PlanGrid Task Report - Dec 4, 2024

#43 [UNIT 999] [NEW] (MISC) AC-3 Alarmed / Missing Sensors

L05649_Blairs Ferry Rd FSU (IA)

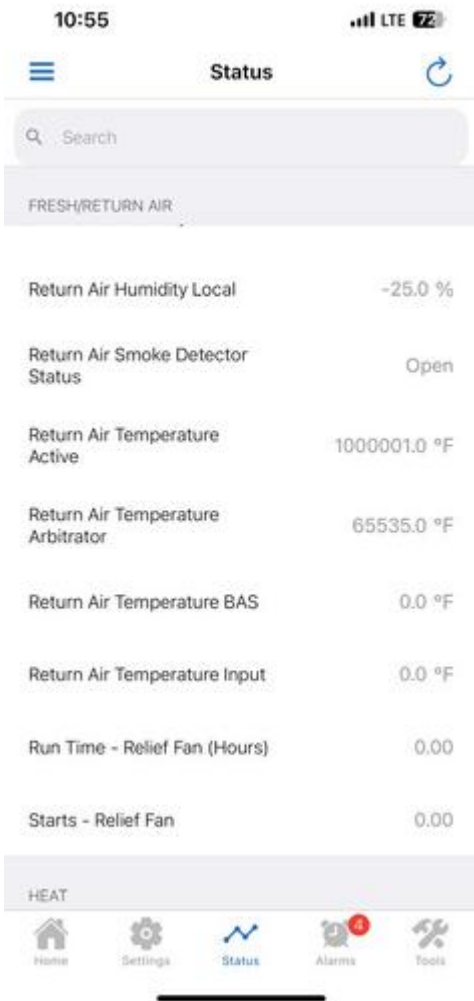
AC-3 is alarmed for Return air Temperature/ Humidity. Return sensors are not installed on this unit and unit is displaying wild readings. Trane was notified, recommend they are contacted again as to absence of sensors and how this impacts operation.

I re-looked at this error code today. There is nothing I can do for it. The unit needs to be looked at by Trane and the circuit board more than likely reprogrammed. The fault code is for sensors that do not exist in this unit. Per Jasen Cox with Xtreme Comfort.
